**ADDENDUM NO. 4**

**CHELSEA**

**Construction of the Silverline Gateway Busway,  
BRT Stations and Bridge Replacement (Steel) Br. No. C-09-001  
Washington Avenue over the MBTA Railroad**

**RESPONSE TO CONTRACTOR QUESTIONS**

NTS

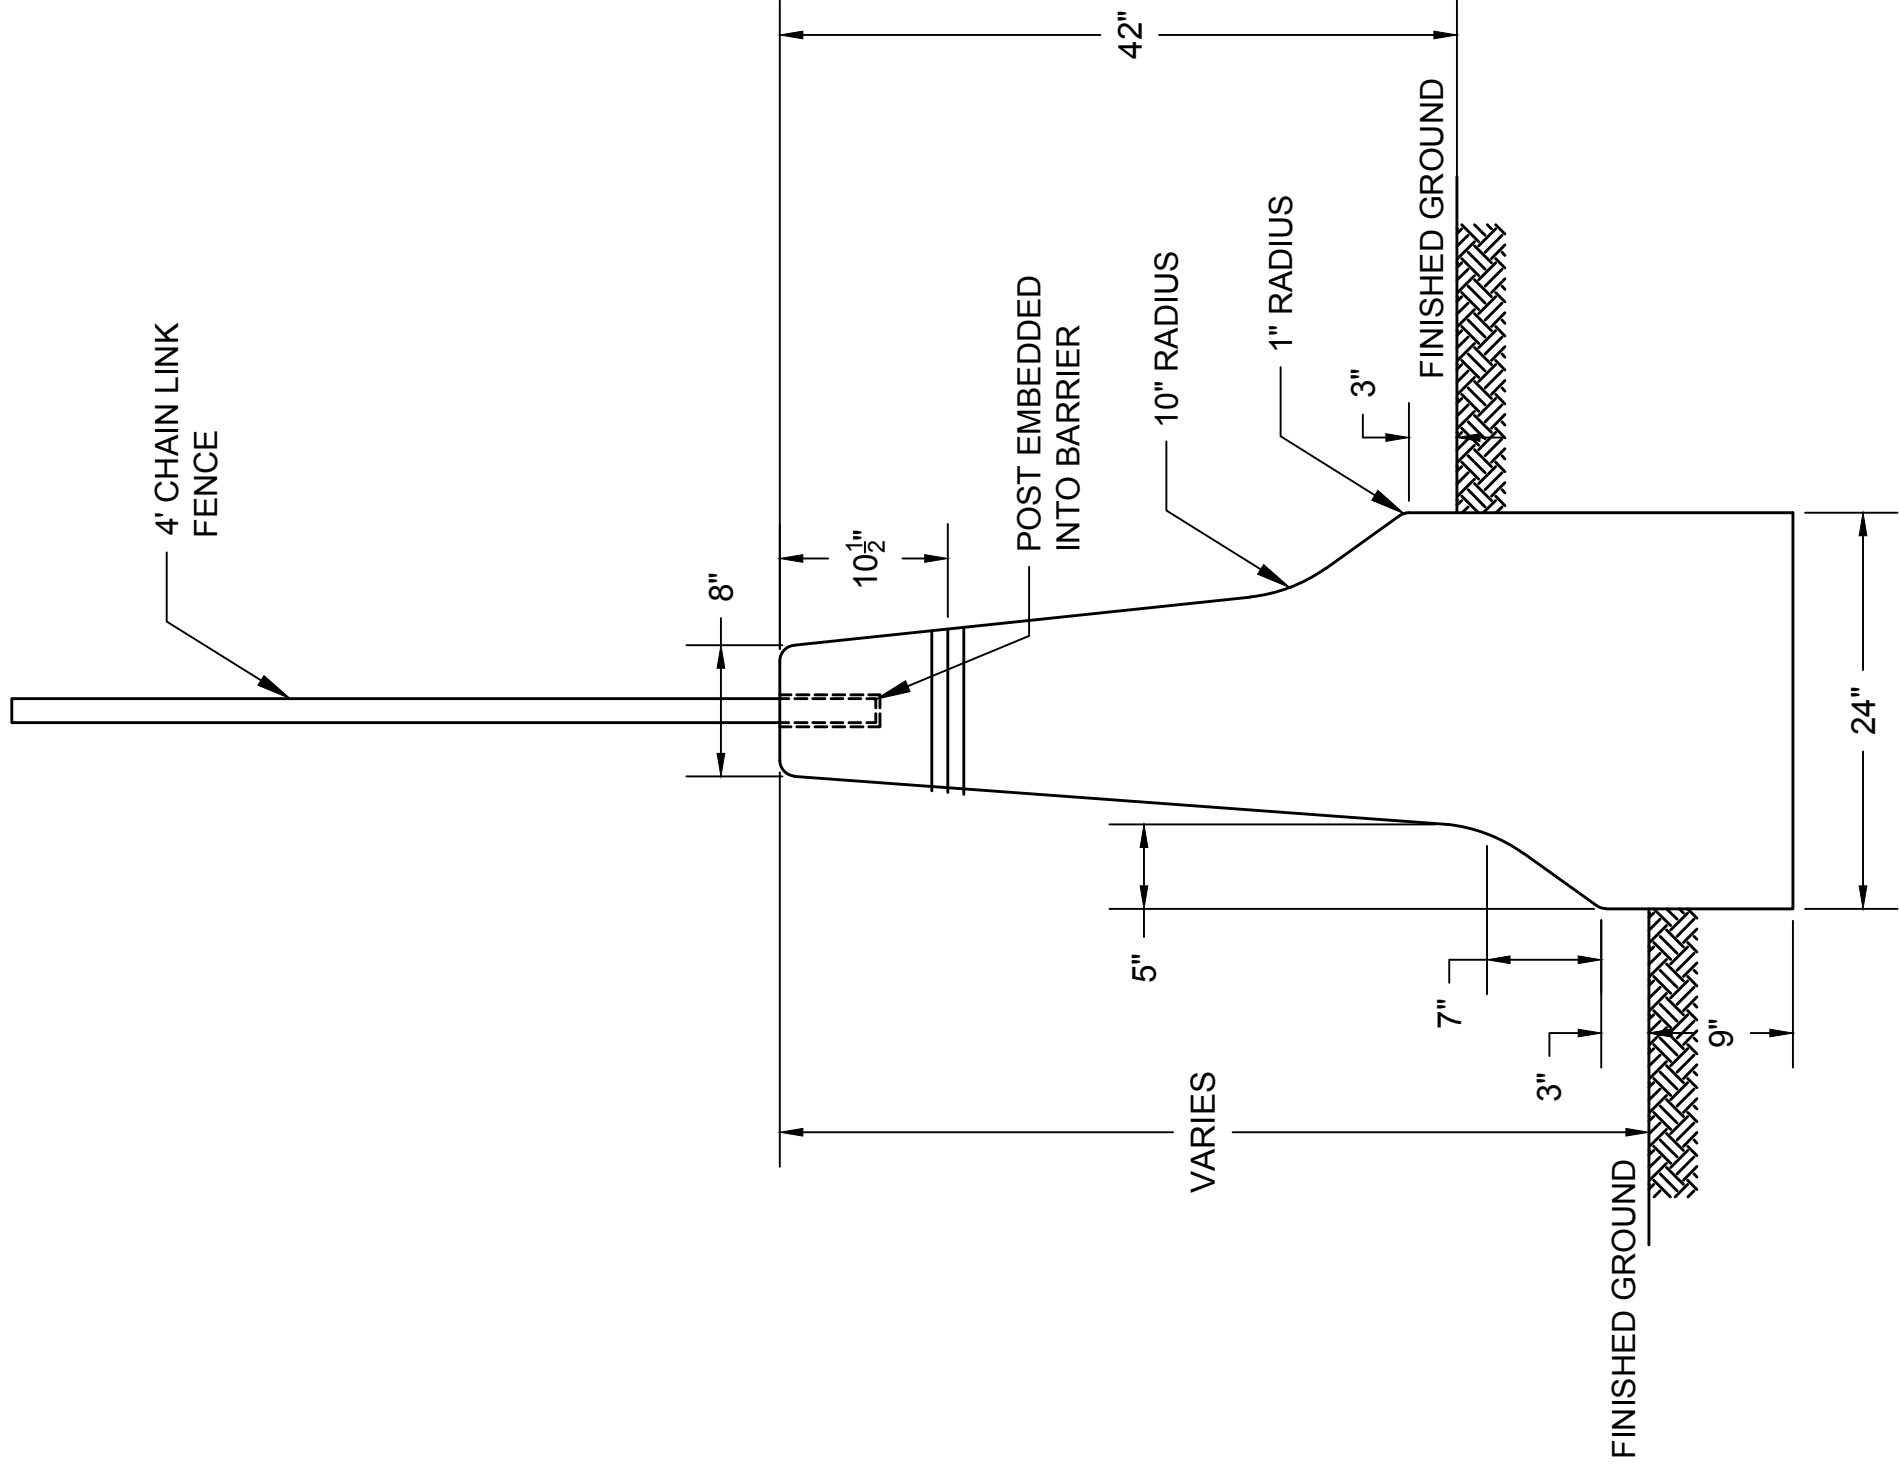
**Question 84)** Regarding 810.11, the detail on revised sheet 15 appears to indicate an existing sleeve surrounding the BellCanada ducts. Please confirm if this is the case, and what is the casing material?

**Question 87)** Under which bid item will the reinforcement for the low retaining walls (detail shown in Addendum #3, sheet 15) be placed under?

**Response 84)** There is no sleeve around the Bell Canada ducts. The detail on sheet 15 has been revised as part of this Addendum No. 4 to clarify.

**Response 87)** The steel reinforcement will be incidental to the cost of the low retaining walls and included in the Contract Unit Price for Item 901.

CONTINUED ON  
SHEET NO. 71

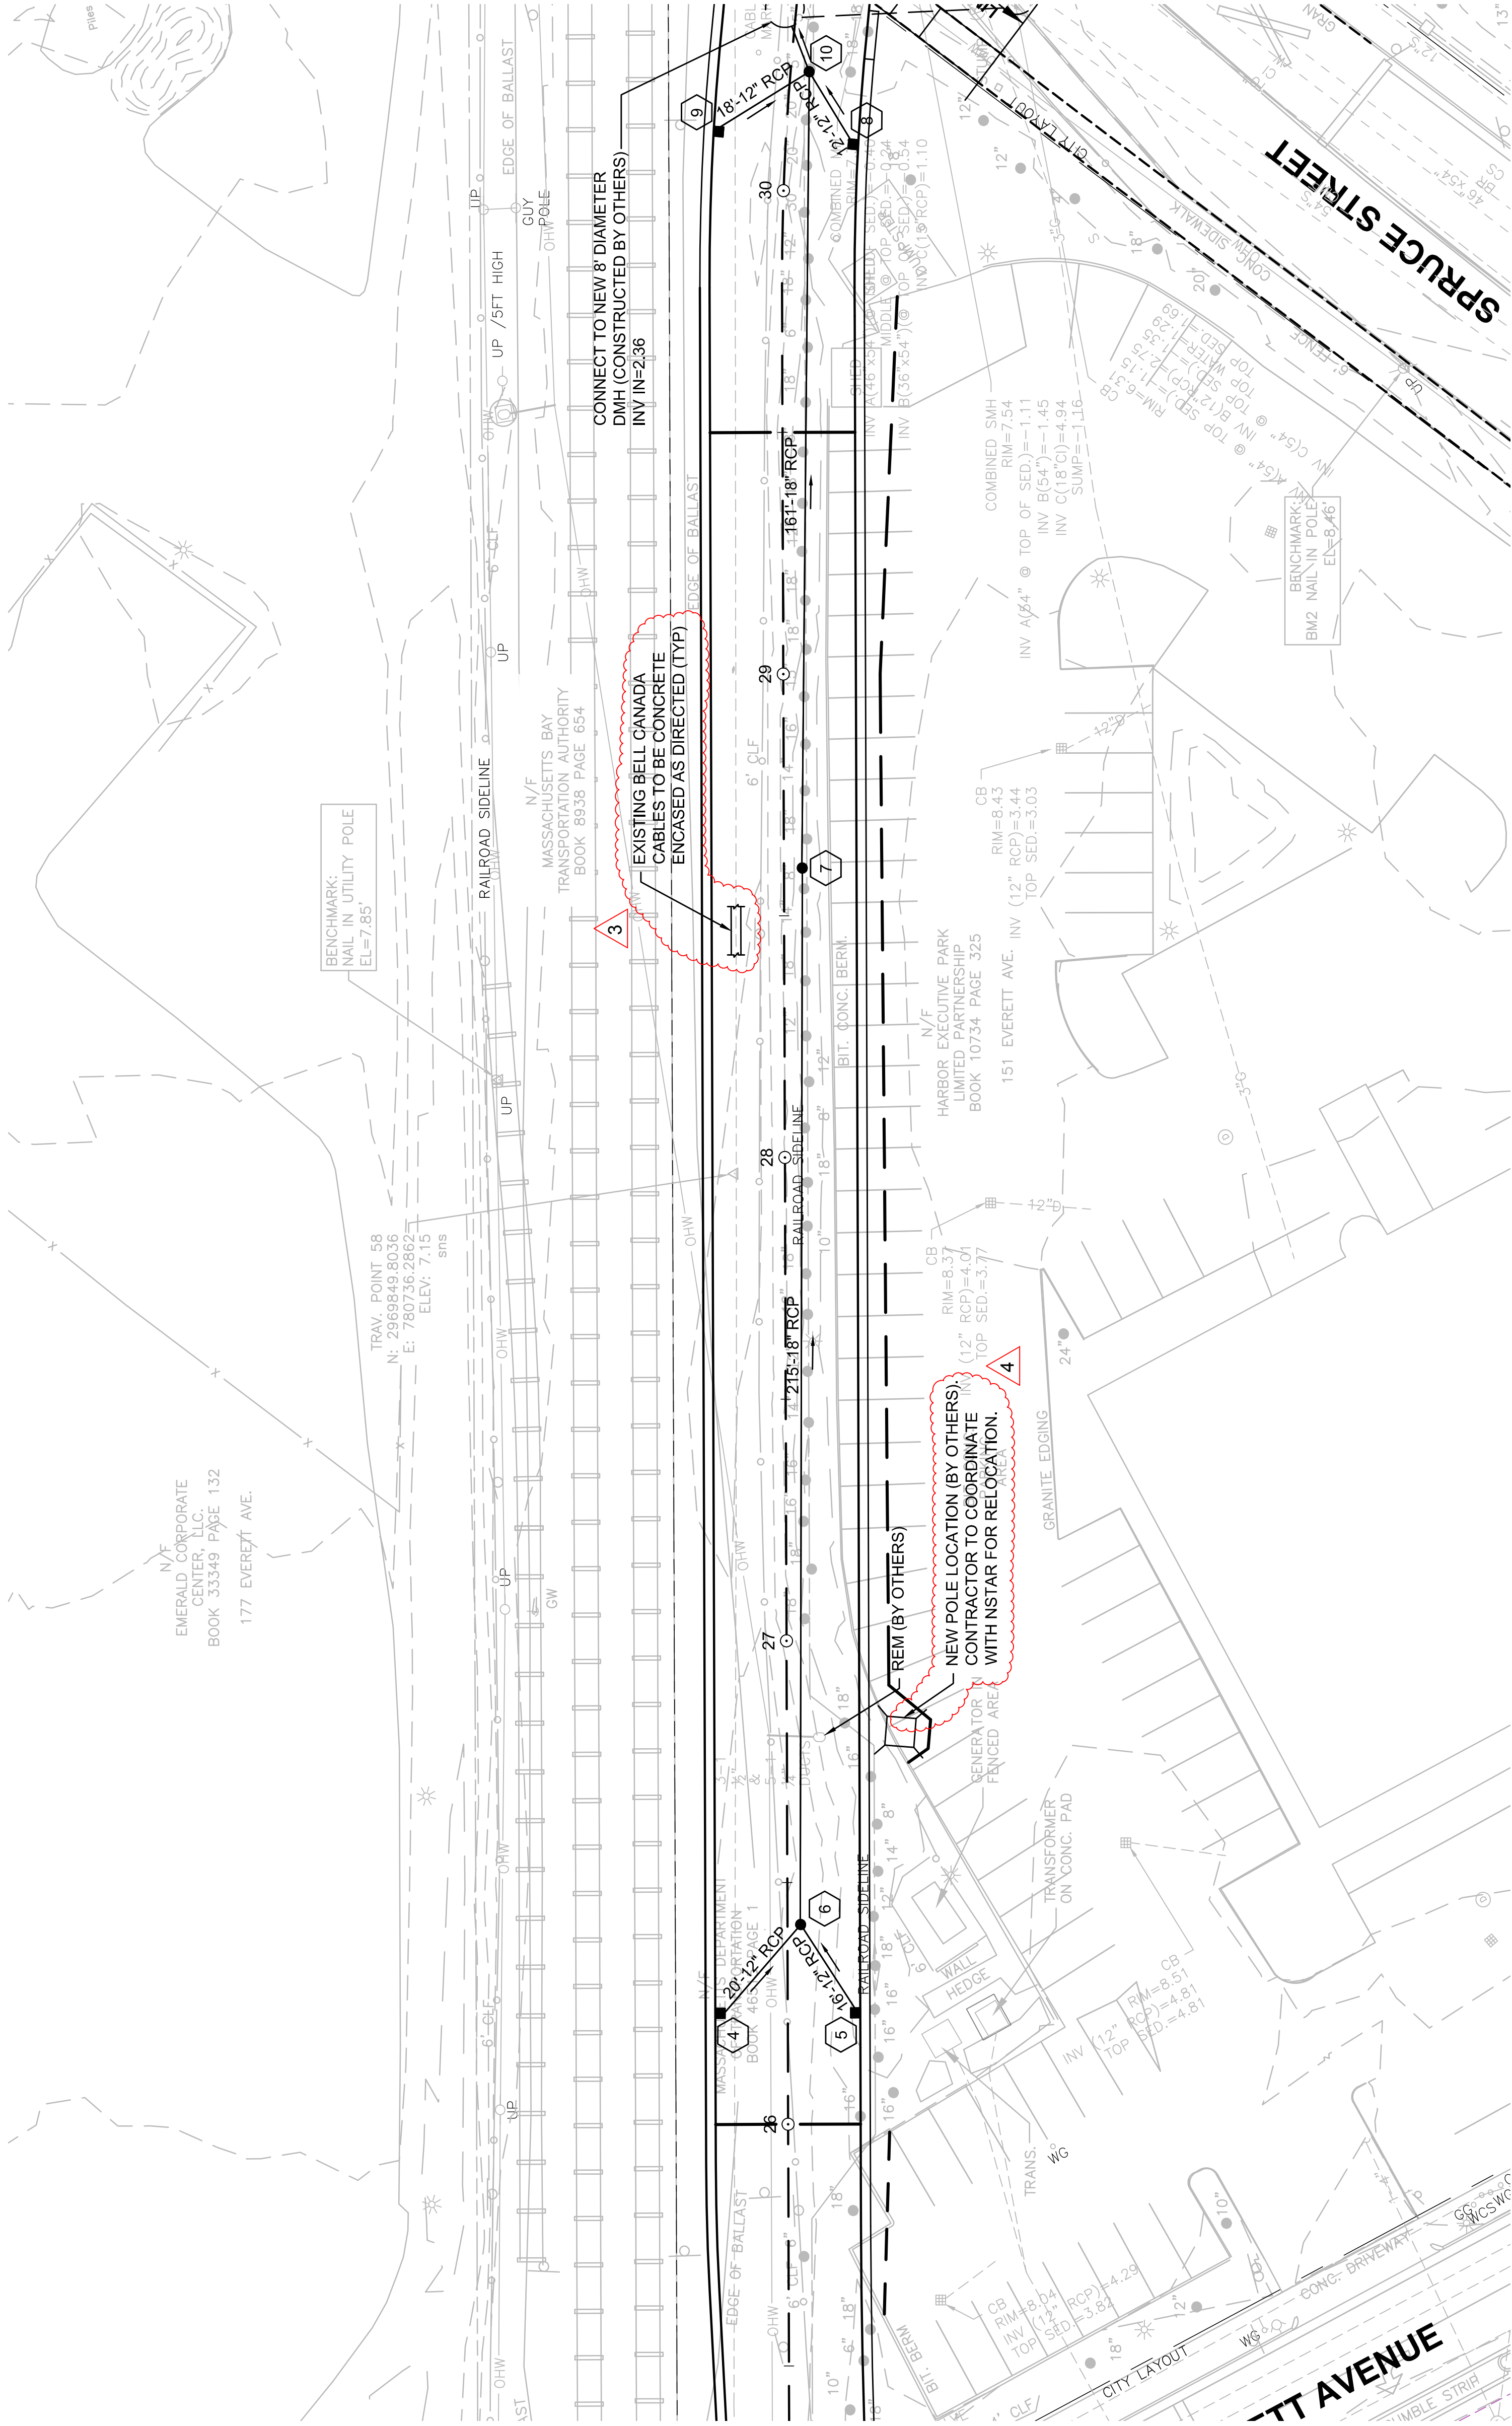
**Question 64)** Utility drawing sheet 71,72,75,77 highlights an object and states “New Pole Location (foundation by contractor, pole by others)”. Please provide a detail for these 5 foundations and confirm they are the responsibility of this contract.

**Response 64)** The foundations as well as the poles will be constructed by NSTAR under a separate contract allowance payment item. Contractor shall be responsible for coordinating his work with that of NSTAR.
